### ZT200 Wheel Motor Mounting Bolts

#### Models Affected: 942215, 942212

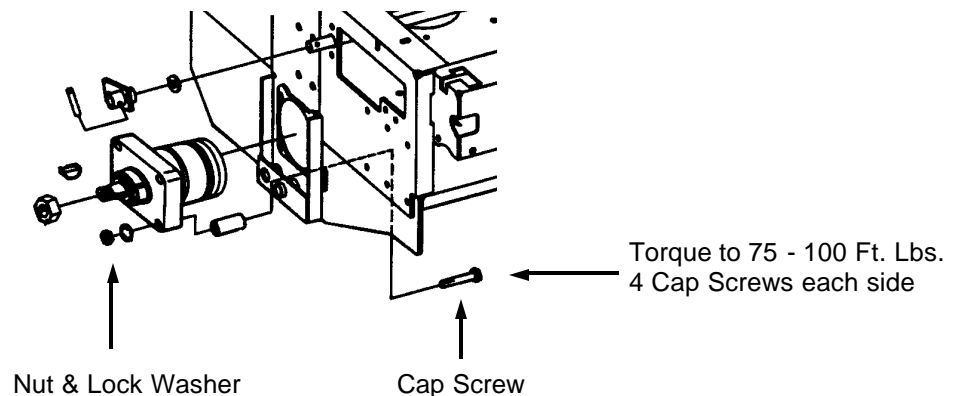
We have had reports from the field that on some new units the wheel motor mounting cap screws have come loose, allowing the wheel motor to come loose from the machine. After investigating we found a faulty torque gun on the assembly line.

New machines set up this season and any machines below serial numbers 9422120506 and 9422150648 currently being set up, should have the drive wheels removed and the four mounting cap screws checked on both sides of the machine to insure a proper torque of 75 - 100 Ft. Lbs. torque.
